Flight Procedures Cover Page	Task Action: FLIGHT CHECK	Task Type: IAP	Estimated Chart Date: 07/16/2020	APWS Task ID: 58446C3919354585844E996A999D4E41	APWS Project ID: 4F6BBB1A38FF4E7BABAED05CC14E0B6D
Procedure: VOR RWY 15L ORIG		Enroute: NO	Specialist: Fulks, Matthew		Agreement Number:
Airport ID: PAGK	Airport Name: GULKANA		Airport City: GULKANA		State: AK
Facility ID: GKN	Facility Type: VOR_DME	Flight Inspection Remark Type: New FC Slot			
<p><b>Procedure Comments:</b>  PAGK/GKN and GKN VOR/DME PENDING DATA USED.  Assigned Mag Var GKN: Old 23E - New 17E   CONTACT DONALD LANIER 405-954-8242</p>

VOR RWY 15L  
GULKANA (GKN) (PAGK)

**CATEGORICAL EXCLUSION DECLARATION**

**VOR RUNWAY 15L**

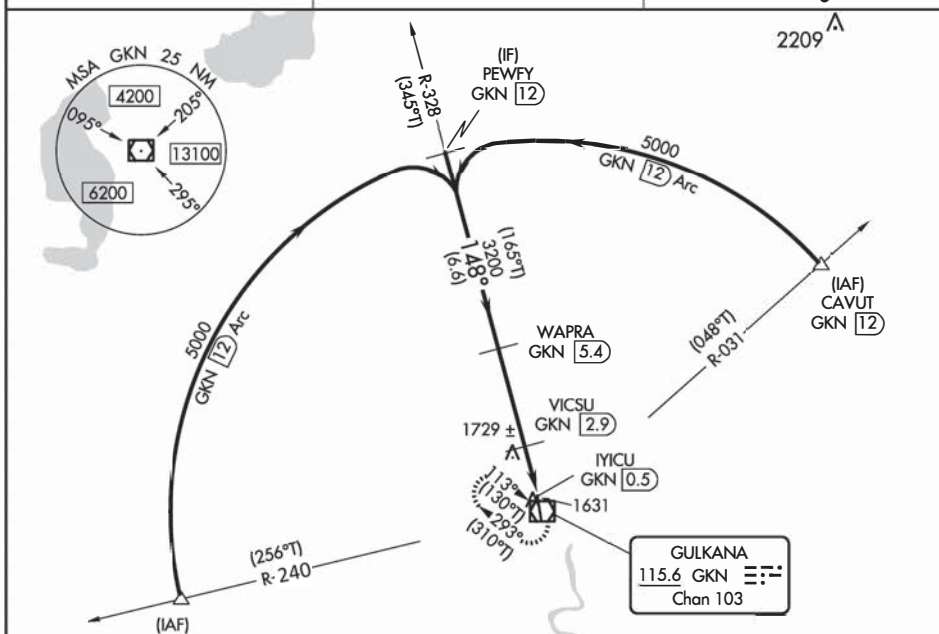
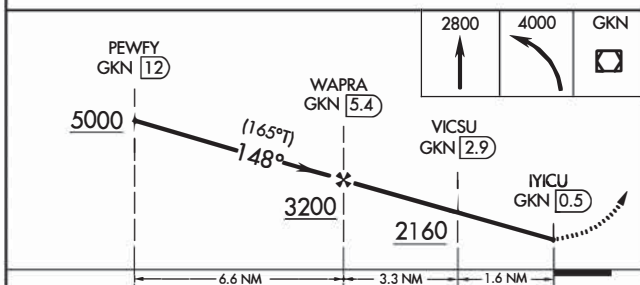
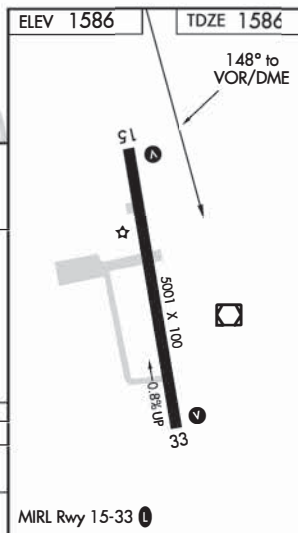
<b>VOR RWY 15L</b>
<b>This procedure is being amended due to encroachment on military operations areas (MOAs):</b> <ol style="list-style-type: none"> <li>1. Remove the procedure turn.</li> <li>2. Move the arcs and associated IAFs and IFs 12 NM inward (closer to the Airport) to remain clear of the MOAs.</li> <li>3. Amend the Climb-in-Hold (C-I-H) inbound course to 130° to remain clear of MOAs.</li> </ol>
The IAF TAKOC is replaced by the new WP206. Altitude at WP206 is 5,000 feet MSL/approximately 2,910 feet AGL.
The IF SOGYO is replaced by the new WP204. Altitude at WP204 is 5,000 feet MSL/approximately 3,045 feet AGL.
The IAF HOVUK is replaced by the new WP205. Altitude at WP205 is 5,000 feet MSL/approximately 2,913 feet AGL.
Add an intermediate stepdown fix WP237 to replace JOGAK. Altitude at WP237 is 4,100 feet MSL/approximately 2,336 feet AGL.
The Textual ODP will be amended to remove references to the GLENNALLEN (GLA) Nondirectional Beacon (NDB) navigational aid (NAVAID).

Adjust RWY headings: <ol style="list-style-type: none"> <li>1. RWY 15L = 154°.</li> <li>2. RWY 33R = 334°.</li> </ol>
Amend inbound heading of holding pattern to 107°.
